1961 Corvette: Service Bulletin: Corvette Grille Vibration

Bulletin No: Page 1, Section XIII, Group 2

Date: February 2, 1961

Corvette Grille
Vibration - 1961
Models

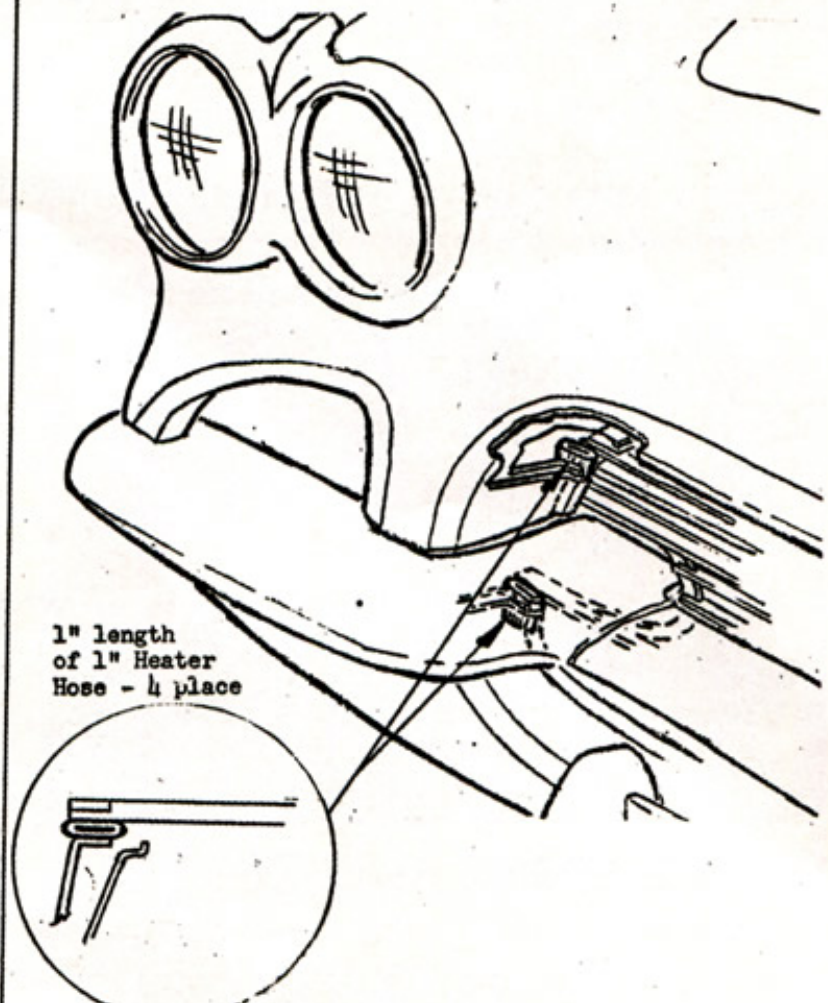
A shrill whistling noise on early production Corvette Models at speeds of 40-60 MPH may be caused by grille vibration. The condition can be minimized by wedging four (4) one inch long pieces of one inch I.D. heater hose between the grille and front end sheet metal as illustrated.
